GRSG/VRU-Proxi Informal Working Group

Japan Proposals for Technical Requirements on Sonars

November 21th 2017
Tokyo

(1) ISO 17386

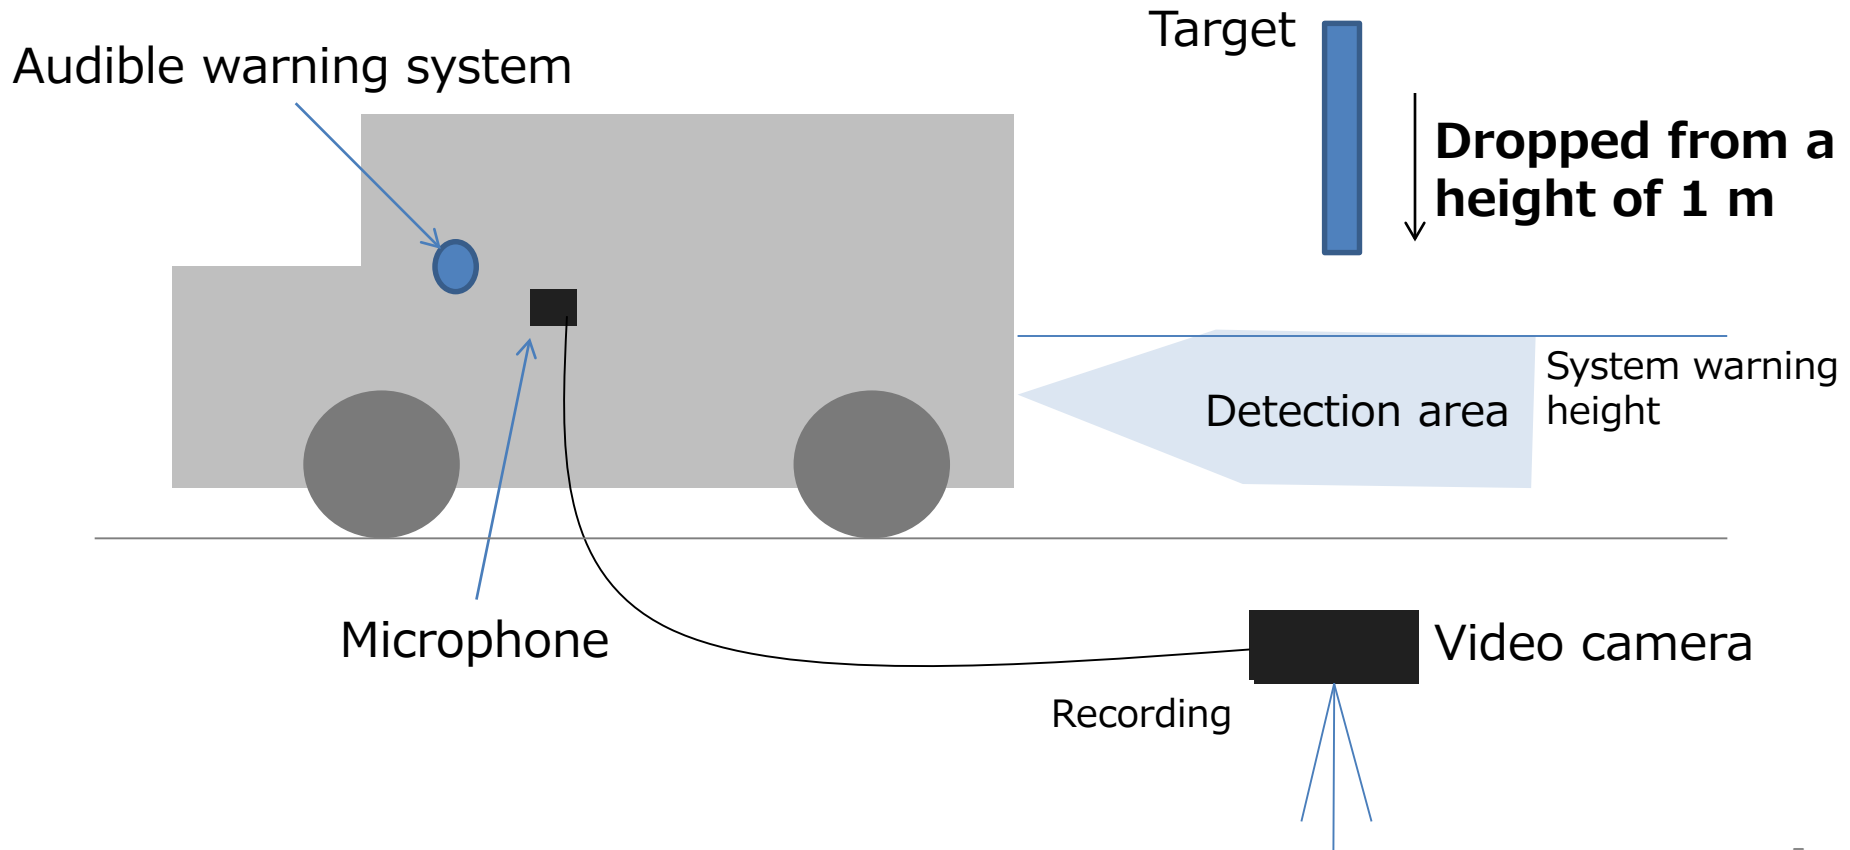
- The target is dropped from a height of 1 m and the response time is measured (video camera image ↔ audible warning).
- A situation where the detection target is landing from above is unrealistic for VRUs detection

(2) Proposal for the response time measurement

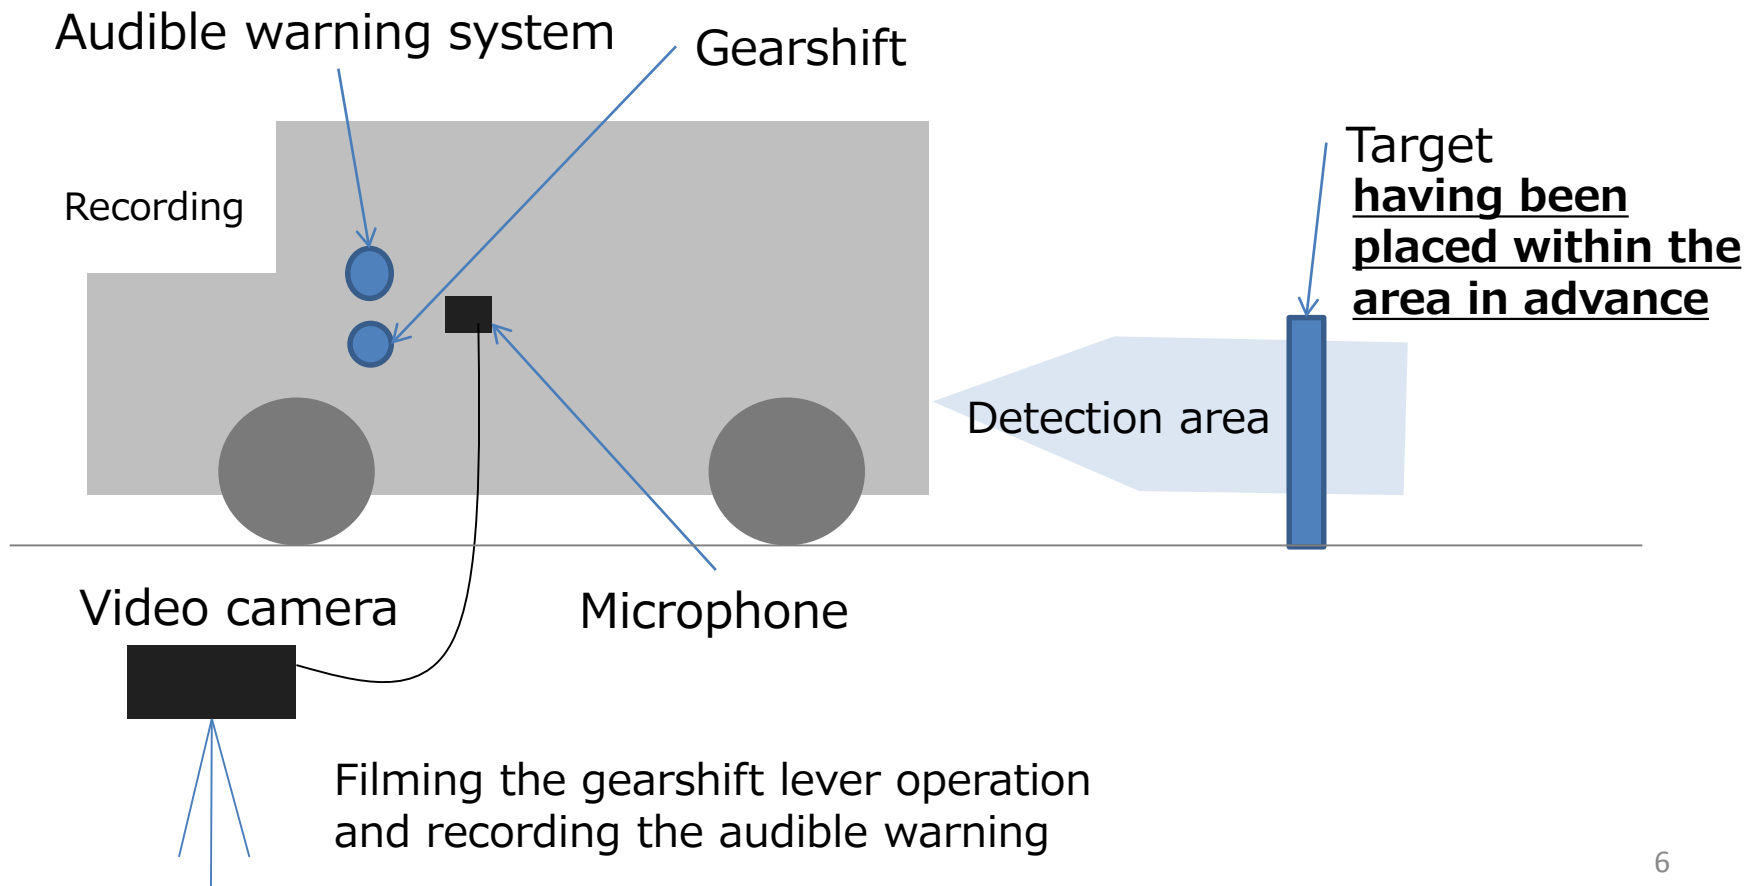
- The system response time should be measured with the time duration from selecting the reverse gear to the warning activation for a stationary target placed in valuation area.

(2) Proposal for minimum coverage

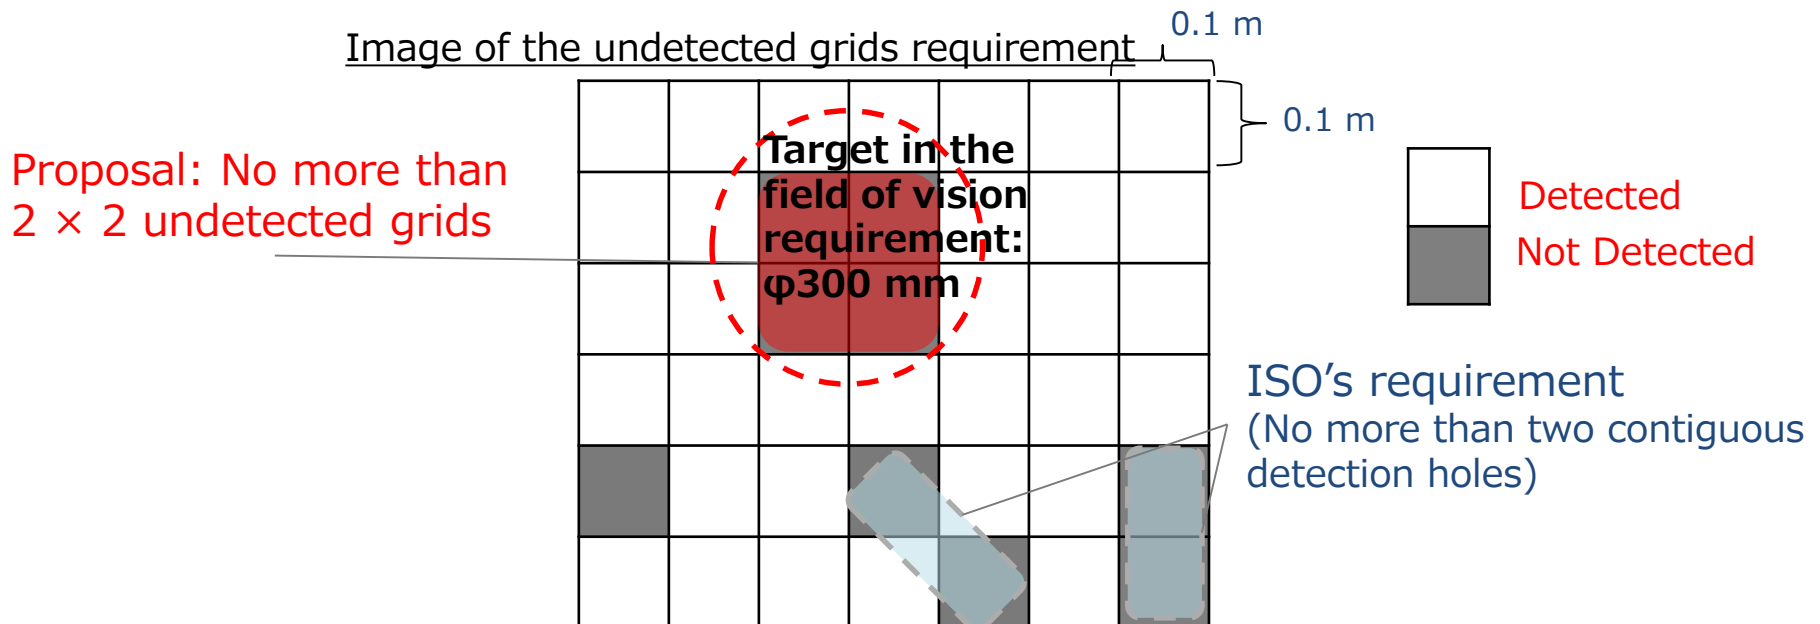
- ISO's requirement "there shall be no more than two contiguous detection holes"(*1) is to avoid property damage by thin object such as pole.

- It is sufficient if the target covers grids equivalent to the size of a person for VRUs detection.
- Change to **"no more than 2 x 2 undetected grids" which considered** as equivalent to the size of a pedestrian.

2.3. Vertical Range Requirement

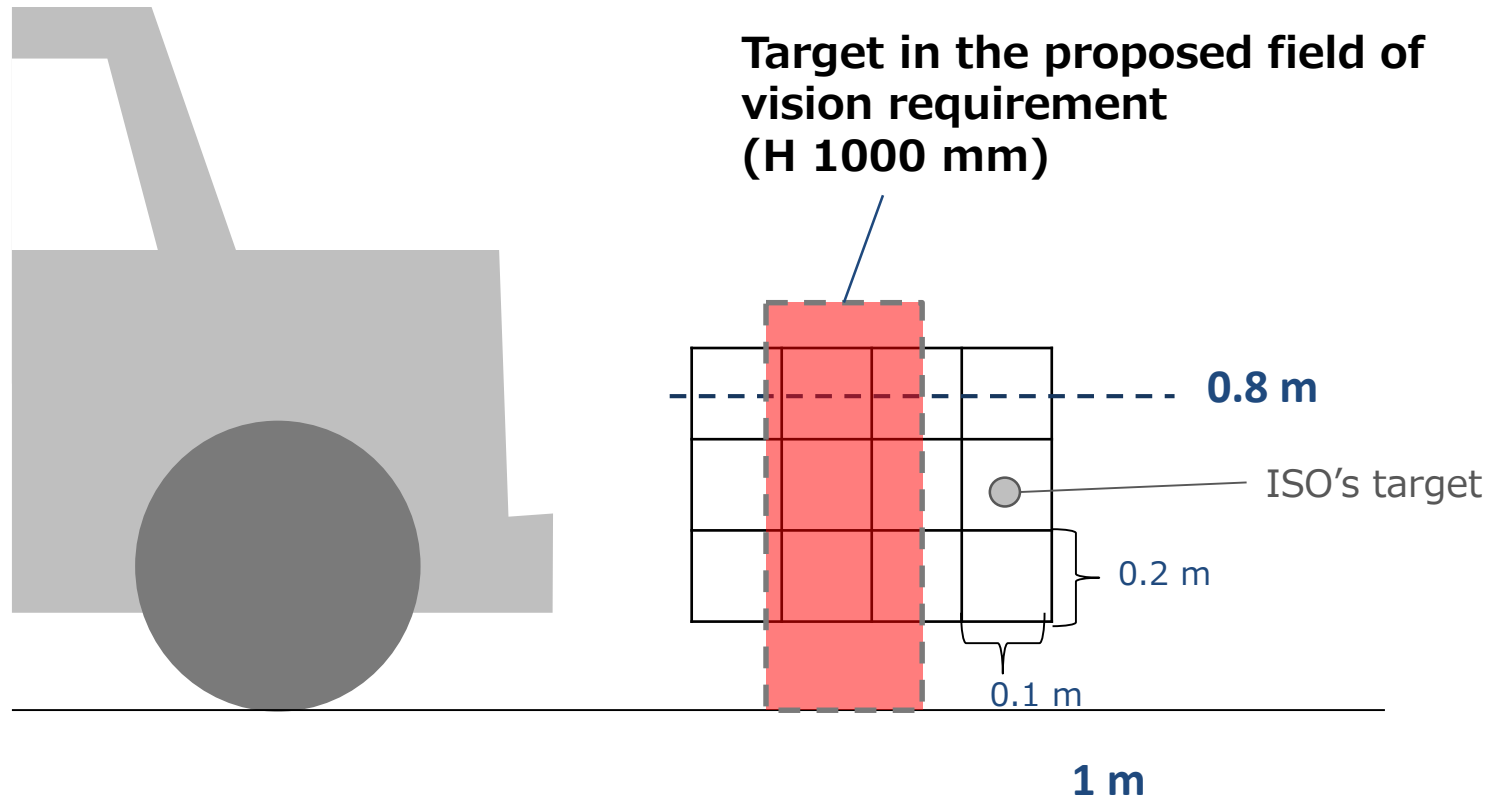
- Vertical range requirement (see below) is defined to avoid property damage by various object, such as luggage carrier of truck.

- Delete vertical range test
